## **IFB No. 24-002 Dykes Road Piping - Federal Grant Funded ARPA Project**

### **Addendum #2**

Addendum based on South Broward Drainage District (SBDD) Permitting Comments  
– **Reference attached updated Plan Sheets**

**C-1.0**

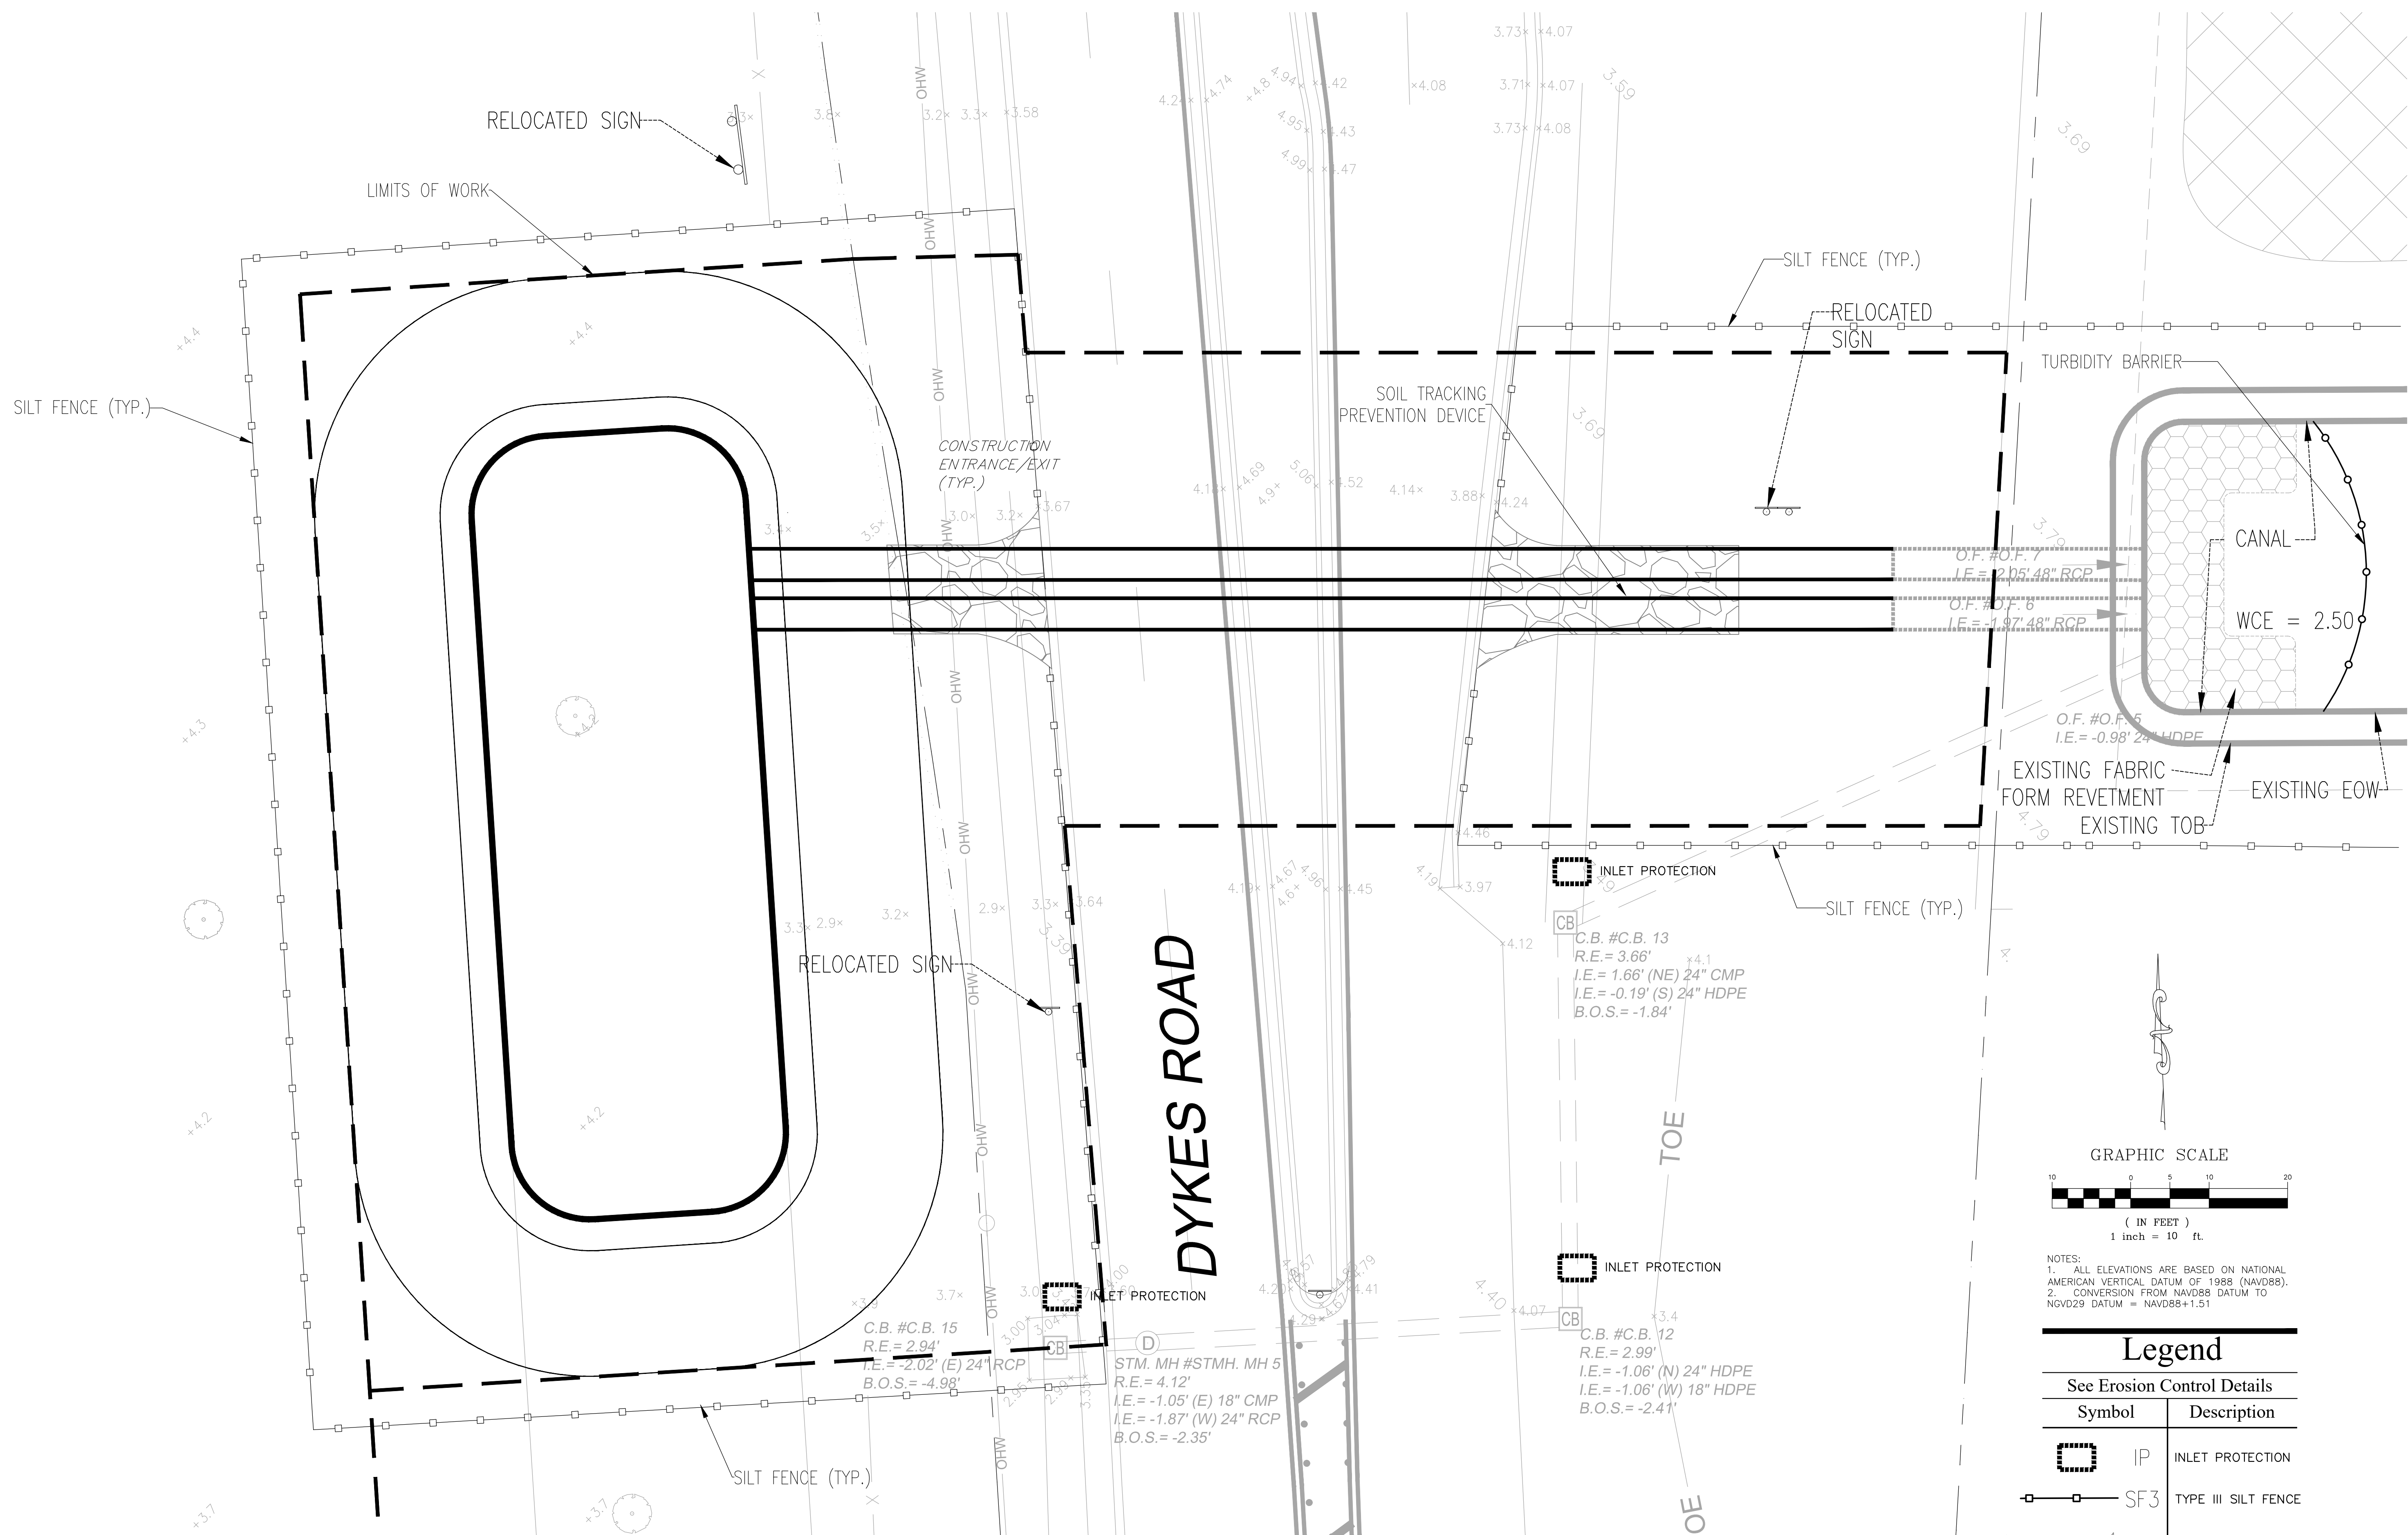
3. SBDD Comment: On the Demolition Plan, the existing tree to be relocated should be noted as "By Others".  
R: Please refer to the revised Note on sheet C-1.0

C-5.0

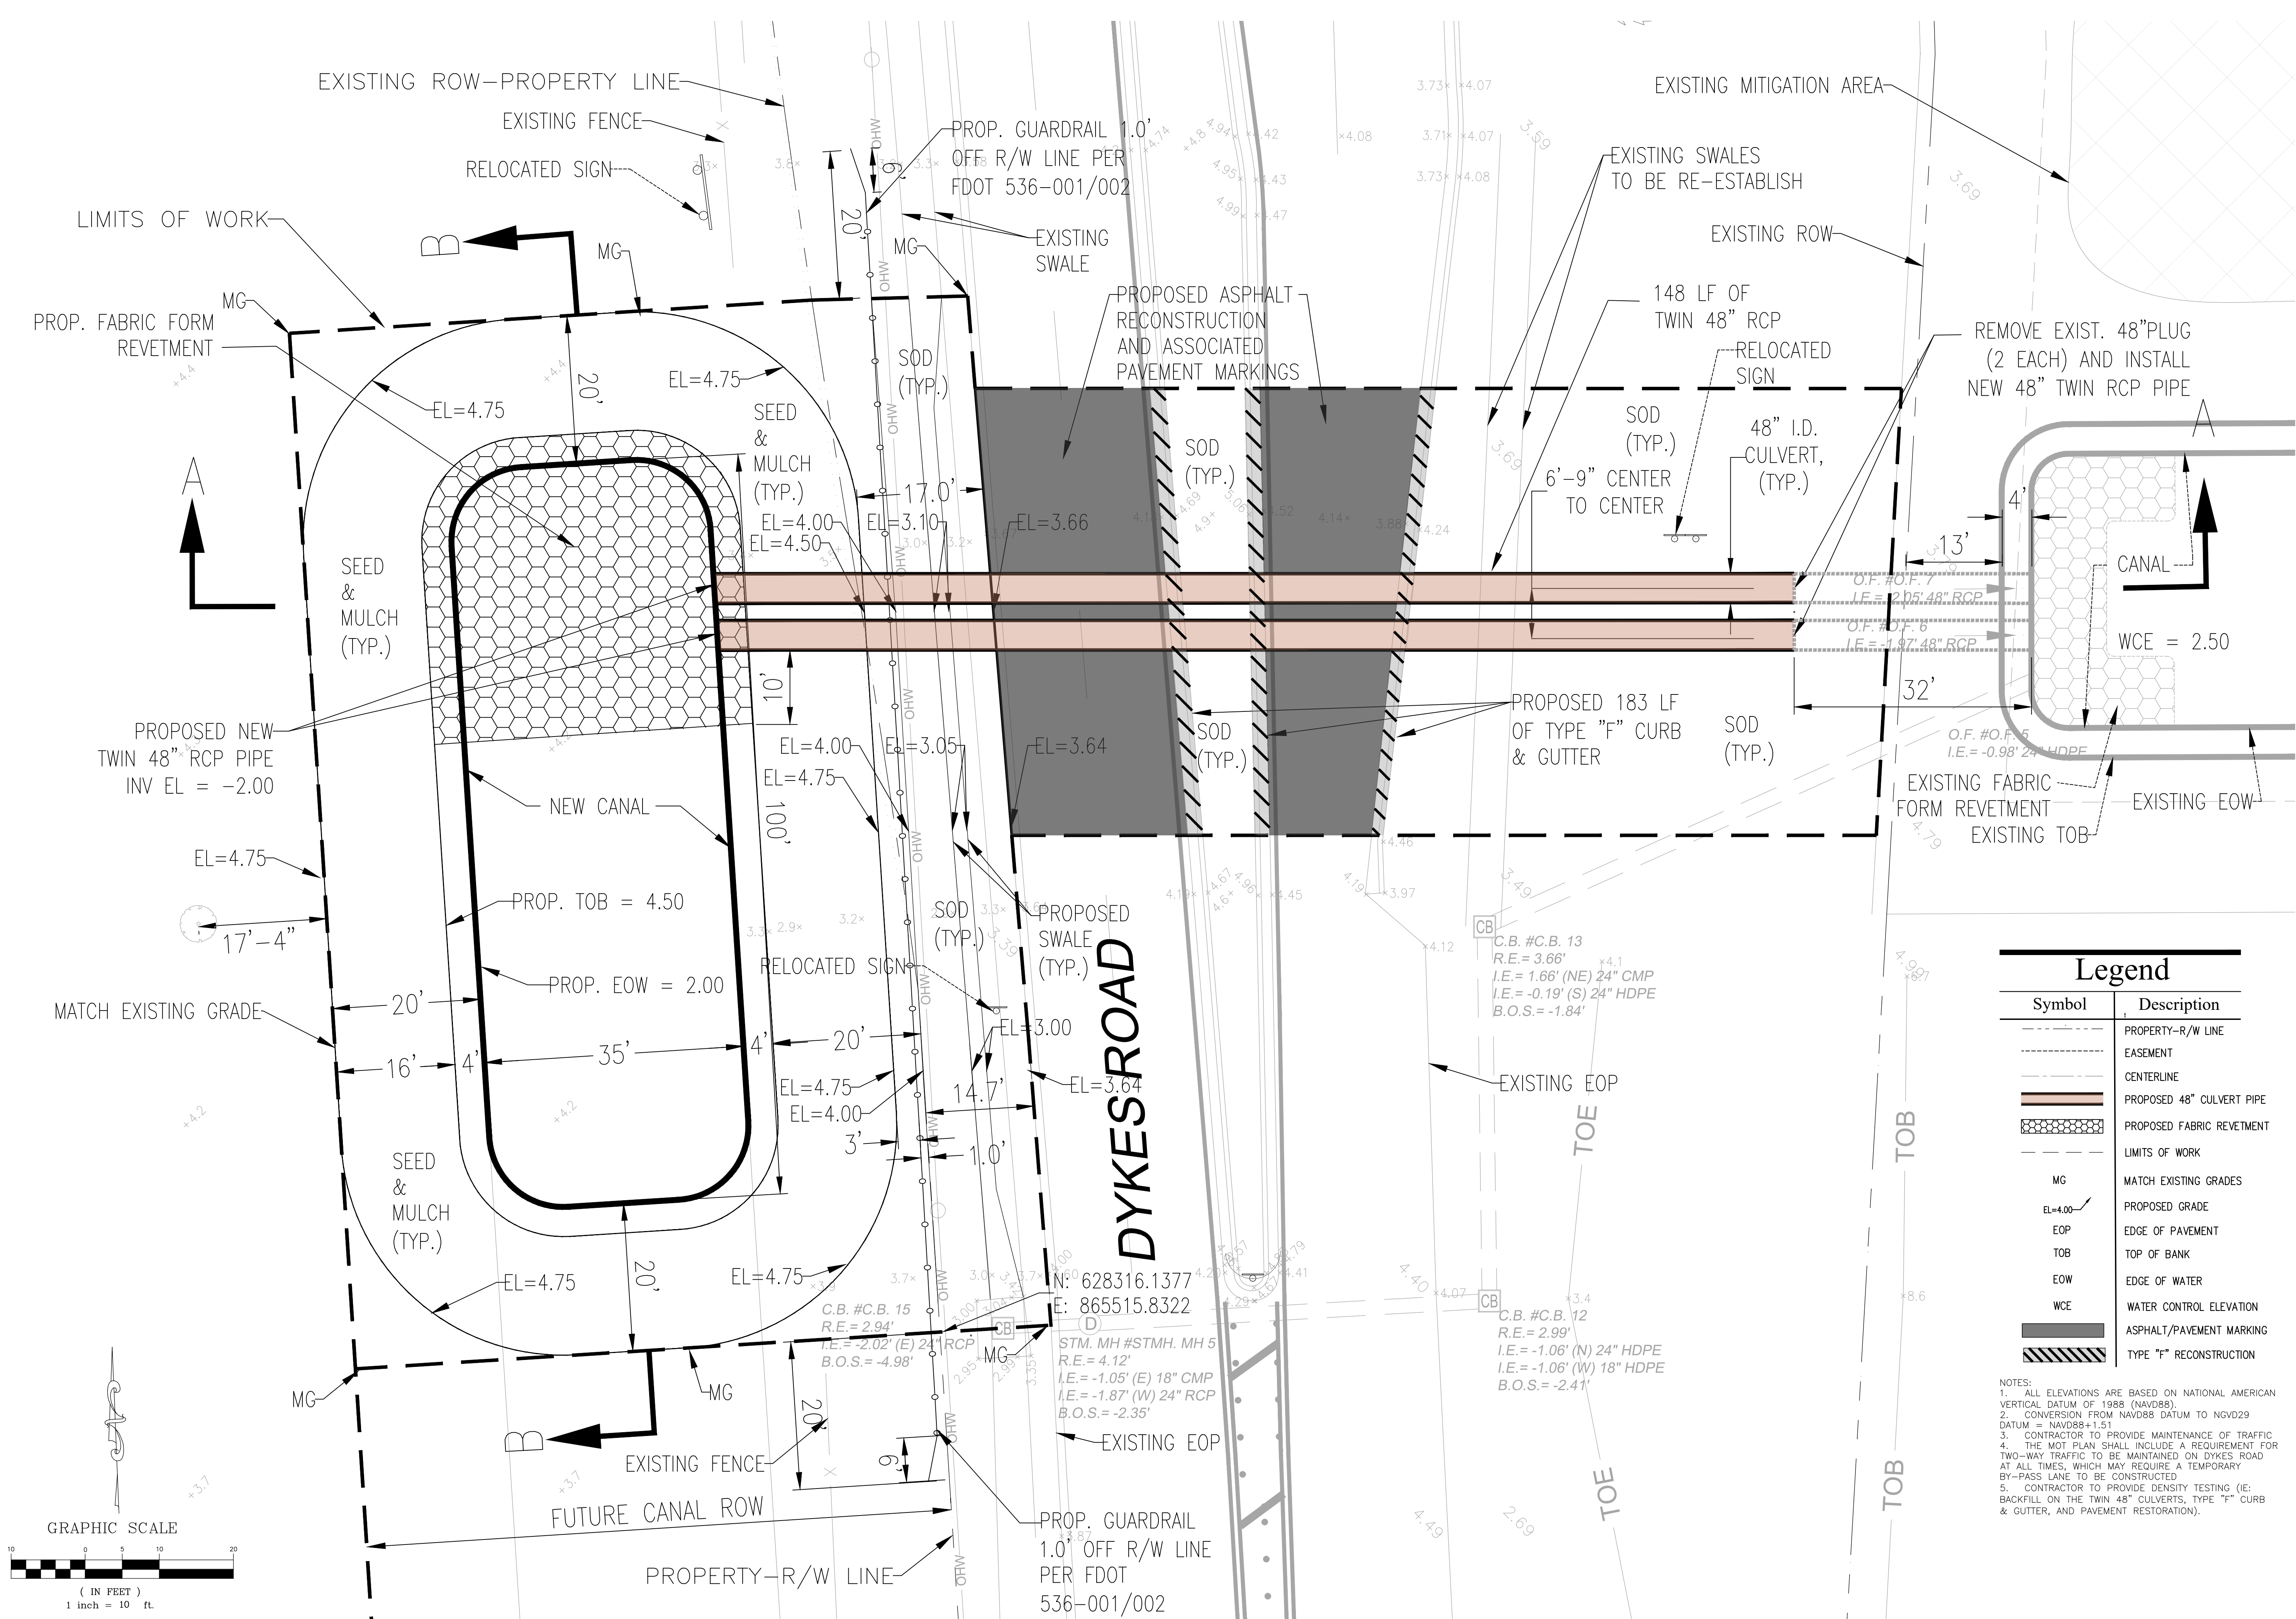
5. SBDD Comment: Suggest adding a note to the plan, or include in the bid documents, the specific requirements for density testing (ie: backfill on the twin 48" culverts, Type "F" curb & gutter, and pavement restoration).

6. SBDD Comment: Suggest adding a Note to the plans indicating that the MOT Plan shall include a requirement for two-way traffic to be maintained on Dykes Road at all times, which may require a temporary by-pass lane to be constructed.

- NOTES:
- ALL ELEVATIONS ARE BASED ON NATIONAL AMERICAN VERTICAL DATUM OF 1988 (NAVD88).
  - CONVERSION FROM NAVD88 DATUM TO NGVD29 DATUM = NAVD88+1.51'
  - CONTRACTOR TO PROVIDE MAINTENANCE OF TRAFFIC
  - THE MOT PLAN SHALL INCLUDE A REQUIREMENT FOR TWO-WAY TRAFFIC TO BE MAINTAINED ON DYKES ROAD AT ALL TIMES, WHICH MAY REQUIRE A TEMPORARY BY-PASS LANE TO BE CONSTRUCTED
  - CONTRACTOR TO PROVIDE DENSITY TESTING (IE: BACKFILL ON THE TWIN 48" CULVERTS, TYPE 'F' CURB & GUTTER, AND PAVEMENT RESTORATION).

## SECTION A-A

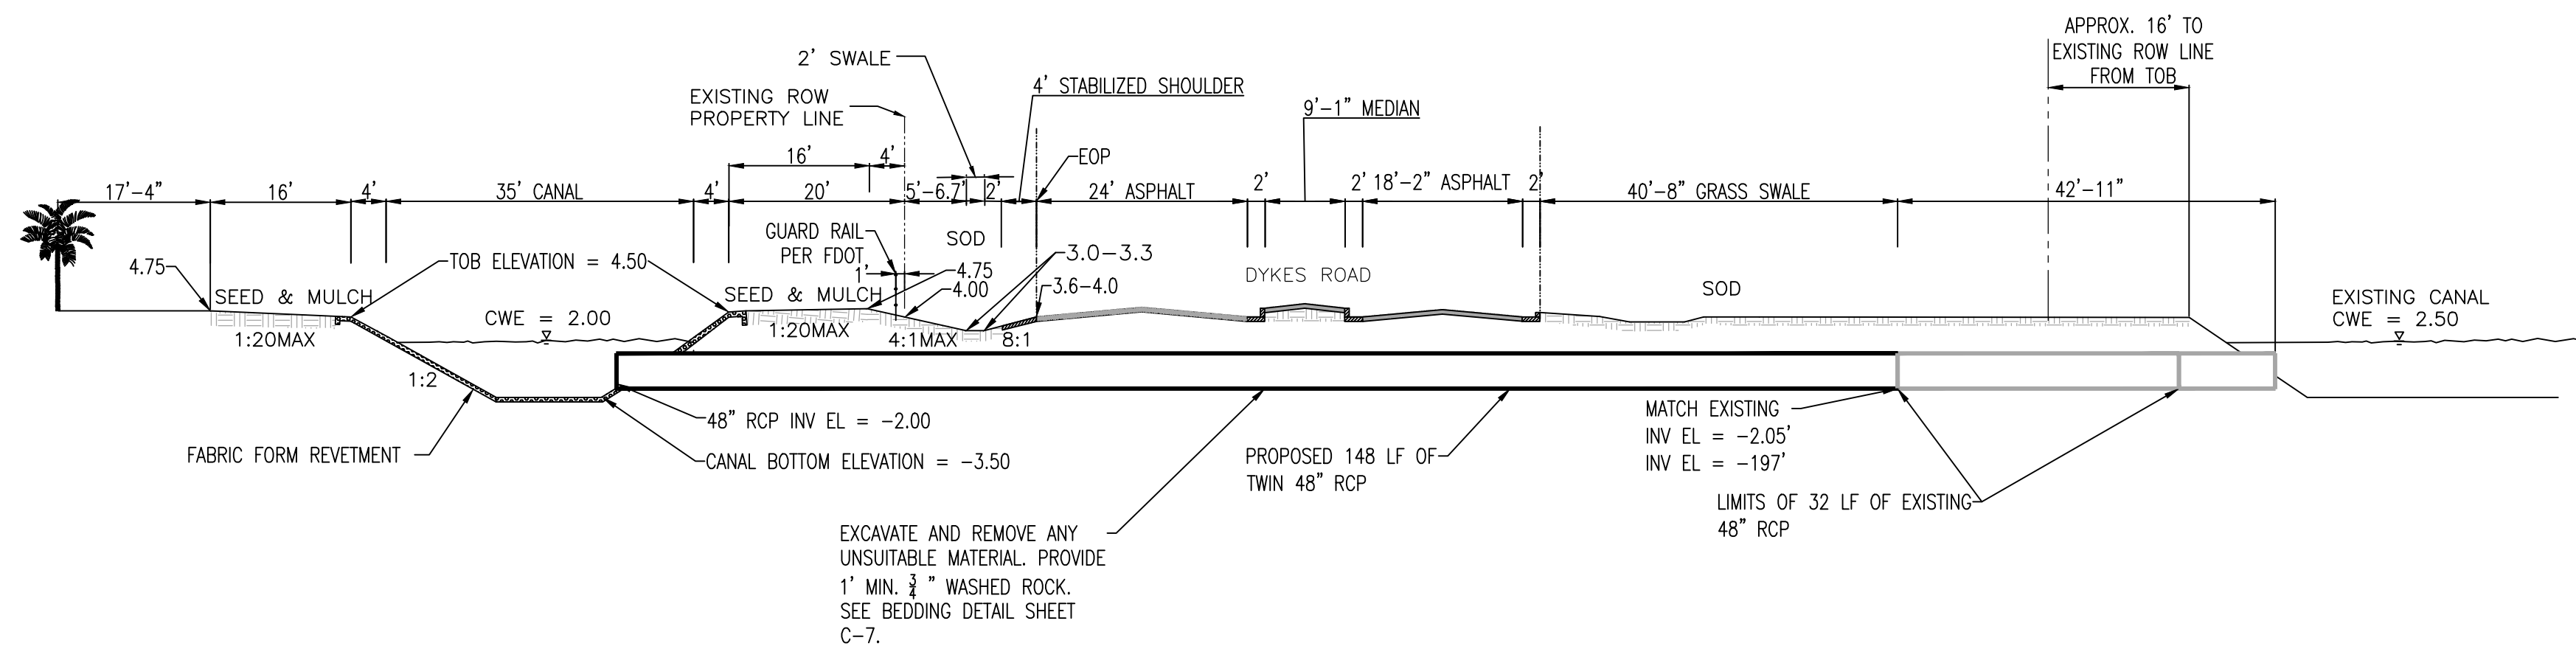
1. SBDD Comment: On Section A-A, label the Fabric Form revetment at the end of the culvert and across the canal.  
R: Please refer to the revised Section A-A sheet C-6.0
